Staff Report & Recommendation

Historic Preservation Board

SUBJECT: HPB24-0625, **947 Lincoln Road.**

An application has been filed requesting a Certificate of Appropriateness for the renovation of the existing building including façade modifications.

Details of the proposed wood panel system, Sheet A301

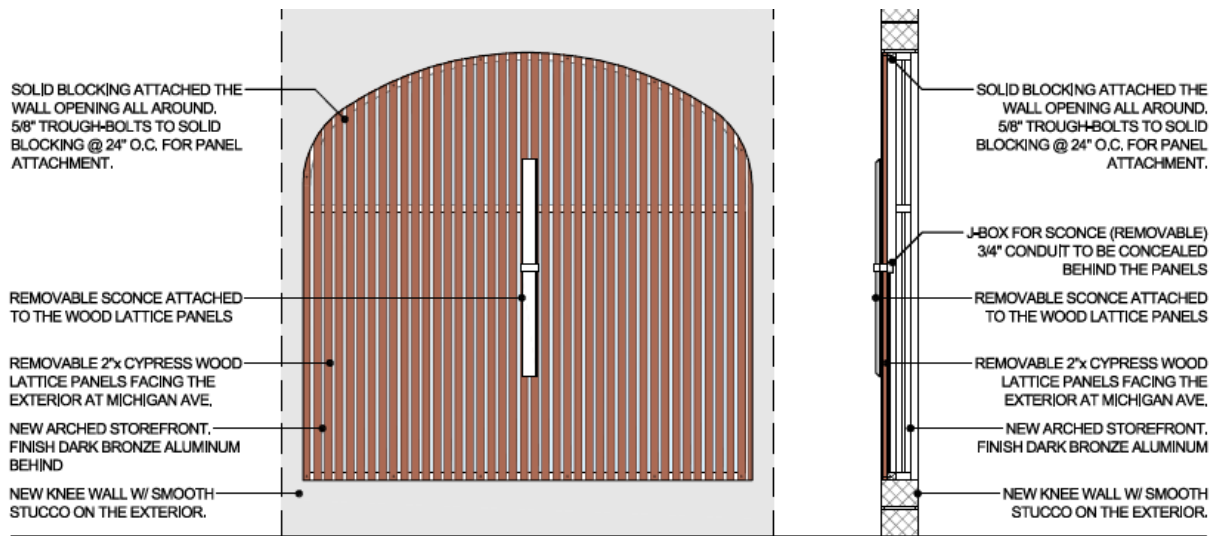
Staff generally has no objection to the exterior modifications proposed including the wood panel systems. As desired by the applicant, the panels will provide a greater level of privacy for guests and as designed, could be easily removed in the future. Staff's only recommendation would be to provide a stucco reveal, demarcating the location of the original arched door opening leading to the second floor from Michigan Avenue.

- b. Final design and details of the wood panel system shall be provided, in a manner to be reviewed and approved by staff consistent with the Certificate of Appropriateness Criteria and/or the directions from the Board. The panels shall be designed to be fully removable.

- c. A stucco reveal demarcating the location of the original arched door opening leading to the second floor from Michigan Avenue shall be introduced, in a manner to be reviewed and approved by staff consistent with the Certificate of Appropriateness Criteria and/or the directions from the Board.
